Shinest Apparels Ltd. (Extension)

8 August 2023

Observations

Missing compression strut along long direction

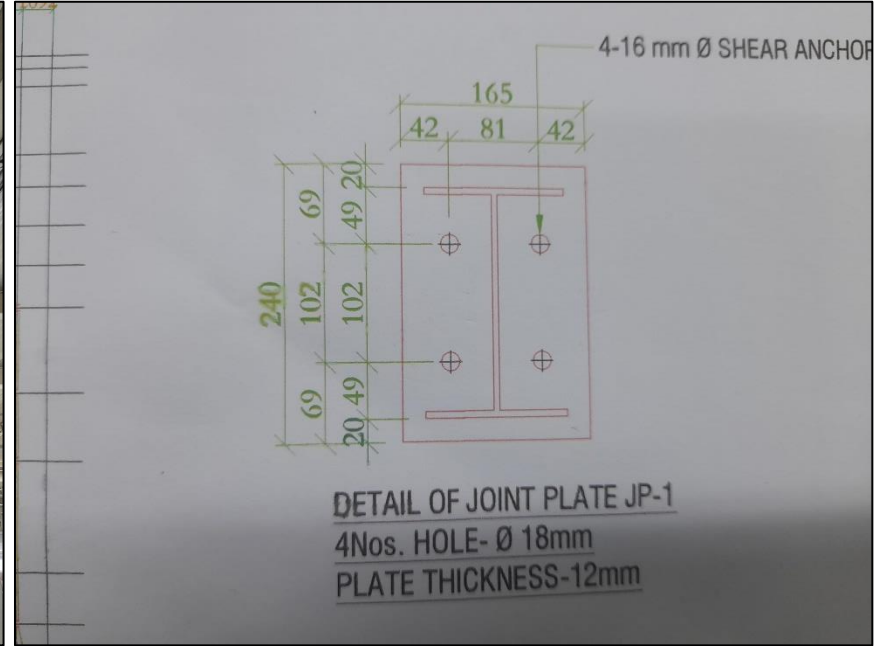
Compression struts were missing along long direction in 3rd floor. The lateral load path is incomplete in long direction. Building engineer is required to check the stability system of the structure for lateral loading and suggest necessary remedial actions where required.

Crack in brick walls

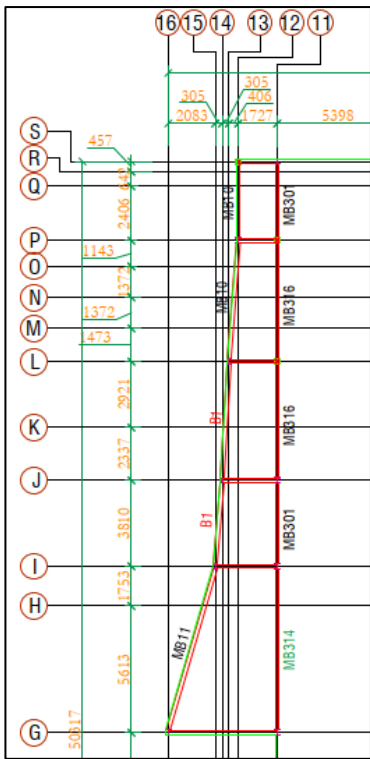
Crack observed in brick walls. The building engineer is required to identify the reason of crack and carry out suitable remedial works.

Bracing on 3rd floor not shown in the retrofitting drawing

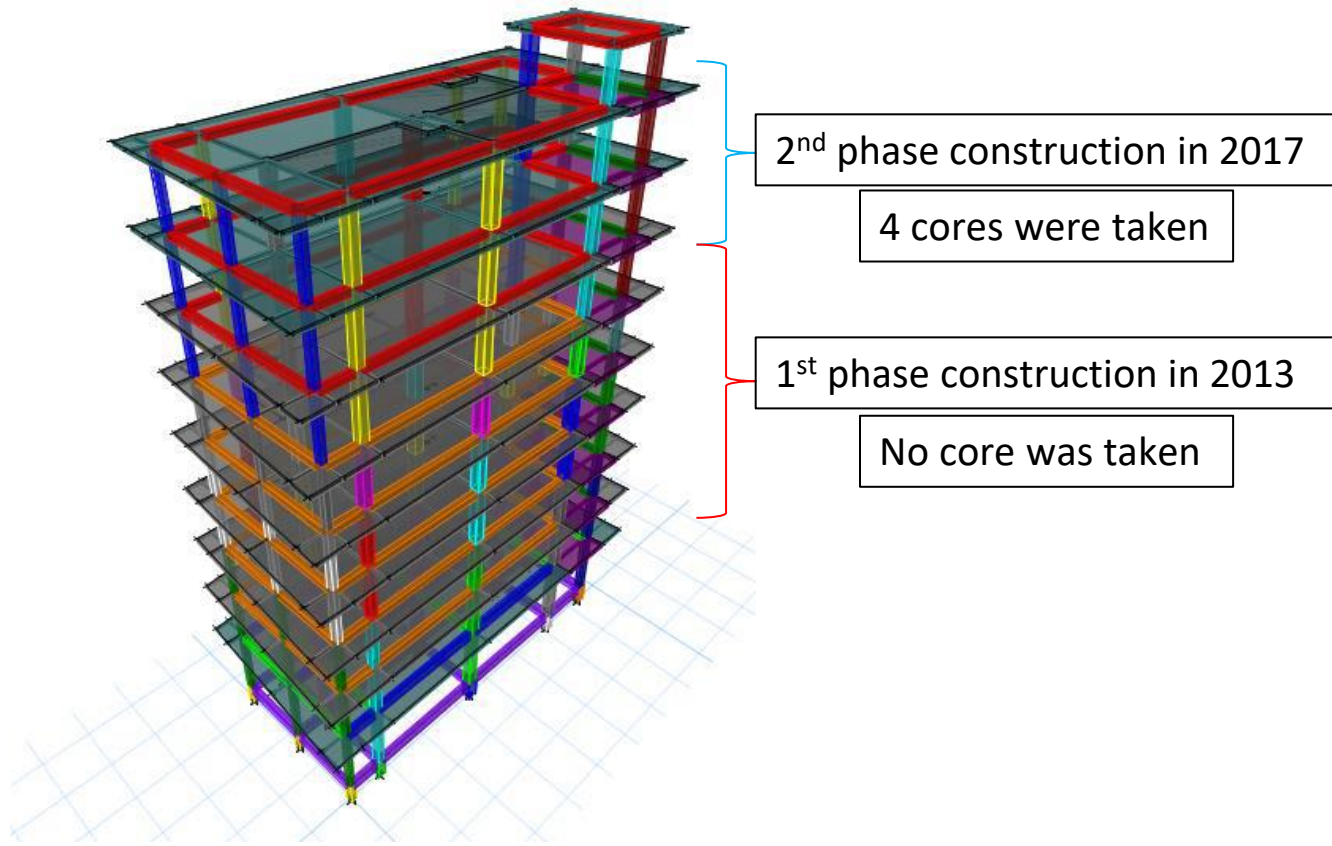
Wall bracing at Grid-1-E~F near to 3rd floor stair not found during the inspection.

Undocumented bracings of 3rd floor shall be incorporated in the drawing. Also, the presence of bracing at grid 1-E~F near stair zone to be investigated.

However, the building engineer is required to survey the structure, prepare accurate as-built drawing and revise the design report based on updated as-built drawing.

Figure 4.2.4: Condition of Column in Grid B

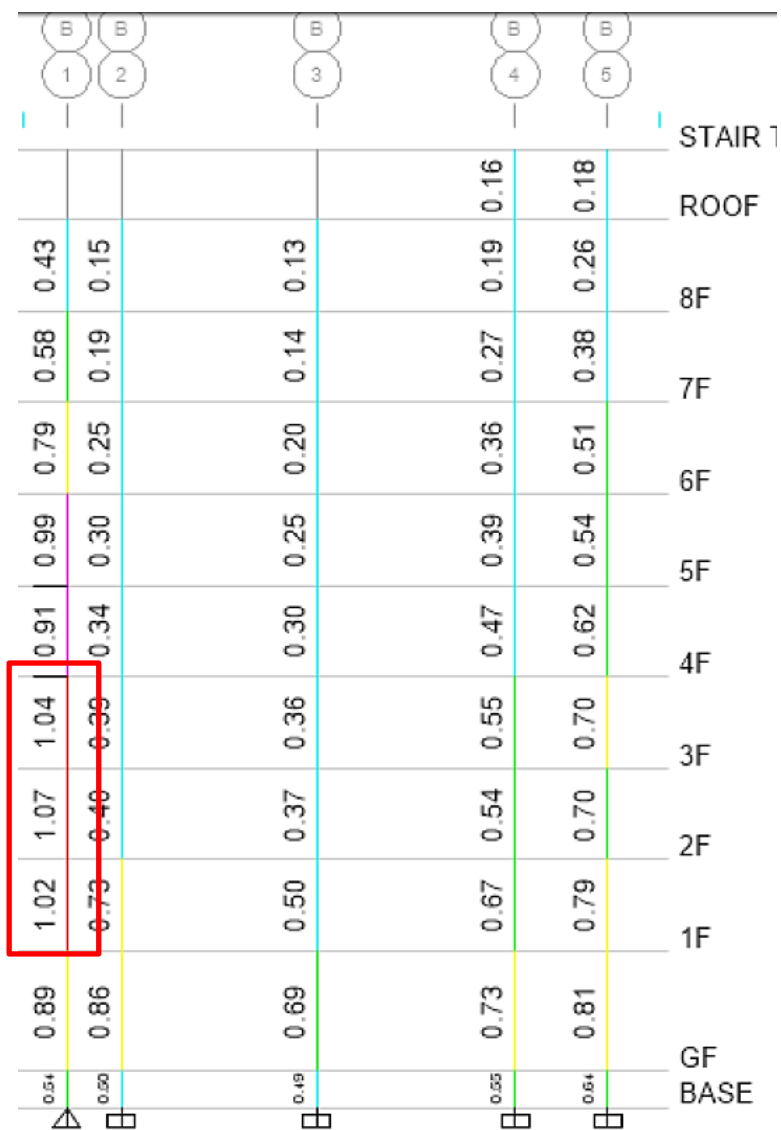
The building was constructed in two phases. The first phase construction was completed in 2013 and second phase construction was completed in 2017. 4 sets of concrete core test report from the columns of second phase construction.

The building engineer is required to take another 4 cores from the column of first phase construction. And revise the design report based on in-situ material strength.

Stress ratio of column in design report

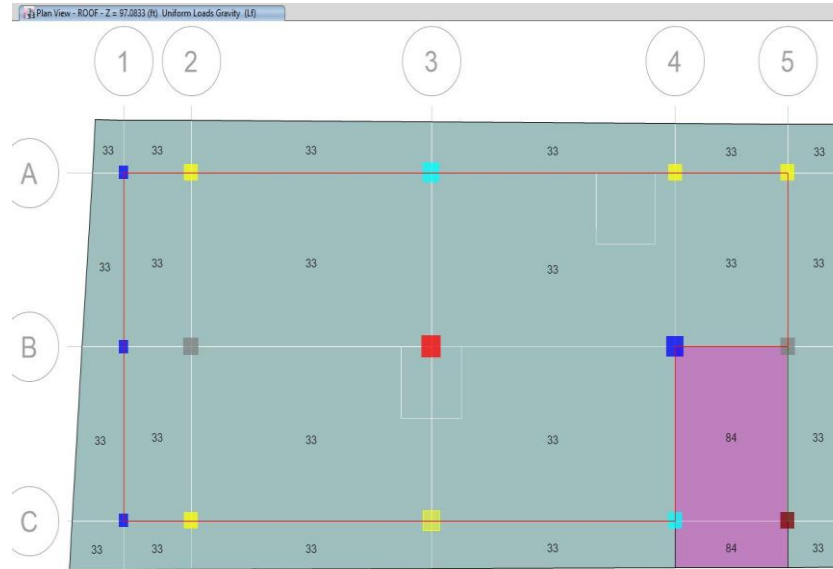
In the Design Report, RC material property considered $f_y=72.5\text{ksi}$ (500 MPa) & $f_c'=5.3\text{ksi}$ (36.6 MPa)

However, in the design report stress ratio of some column are exceeds normal design limit (PMM ratio > 1.00). Factory engineer is required to re-check the analysis and provide necessary alternative accordingly.

Toilet zone location on several floors

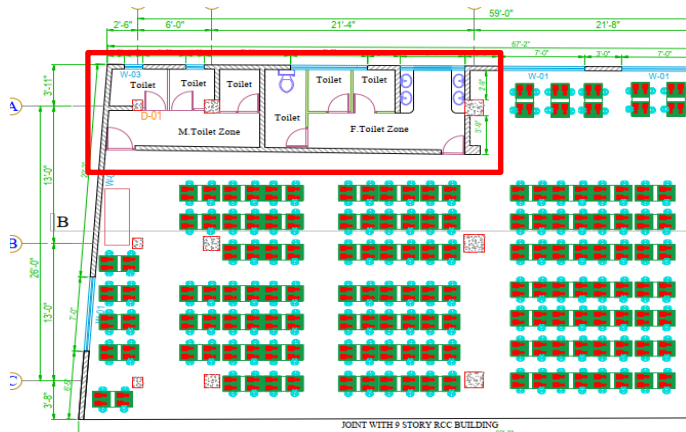
Water tank load and toilet wall & floor built-up loads are not considered in the drawings, floor load plan and design report.

The building engineer is required to incorporate the water tank and floor built-ups in the as-built drawing & floor load plan and revise the design report accordingly.

Figure 3.8.1: Applied Floor Finish in Typical Floor (20psf)

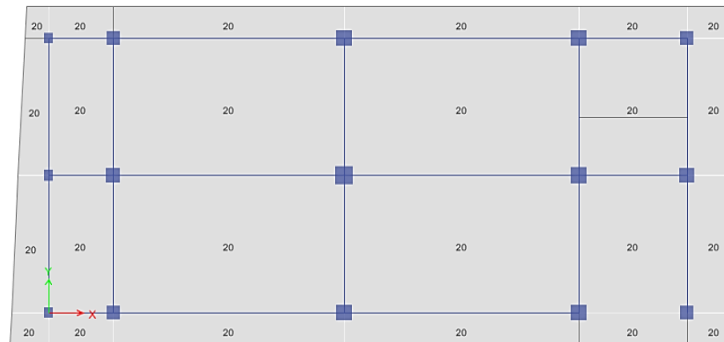
Only 1 kPa (20 psf) floor finish load considered in the model

As per live load table (6.2.3) of BNBC-2006

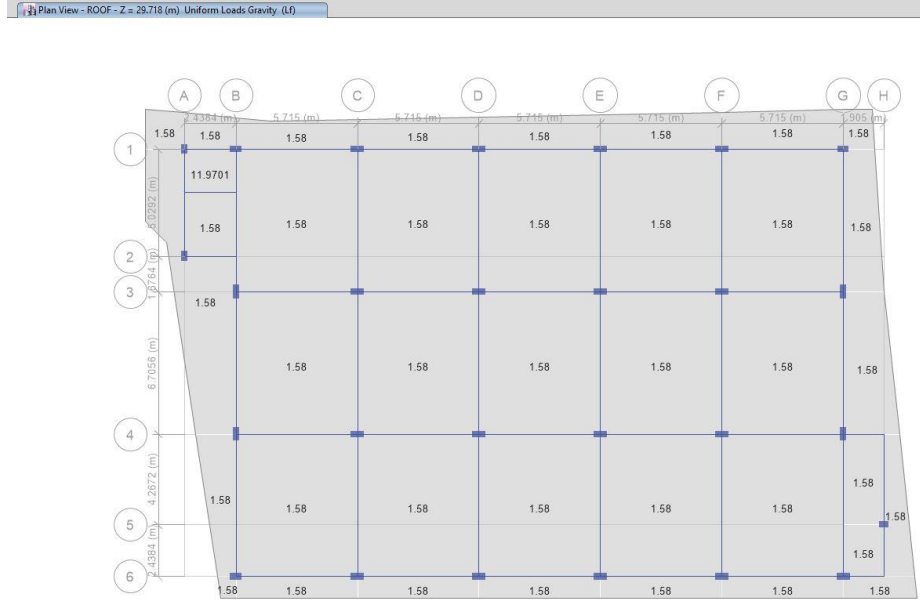
Minimum floor live load is 3 kPa.

As per BNBC-2006, the minimum floor live load for the industrial building is 3 kPa. The building engineer is required to update the floor live load as per BNBC requirement and revise the structural analysis and design report of the building accordingly. Submit the revised design documents to the RSC for review.
